Piston Replacement for 2004–2007 Ford E-Series

#102

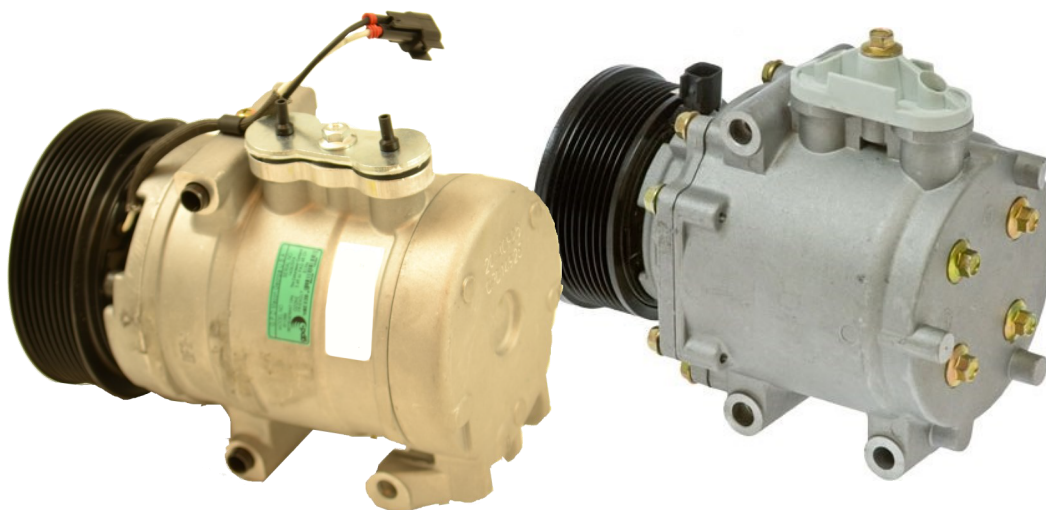
The piston compressor is a direct bolt-off, bolt-on replacement for the scroll style compressor. gpd's piston design is more tolerable of debris left in the A/C system and performs better at lower RPMs than the O.E. scroll.

All gpd compressors come with the correct amount of oil for the A/C system. No matter which compressor is chosen for replacement, gpd strongly recommends that the condenser is replaced and the system is flushed.
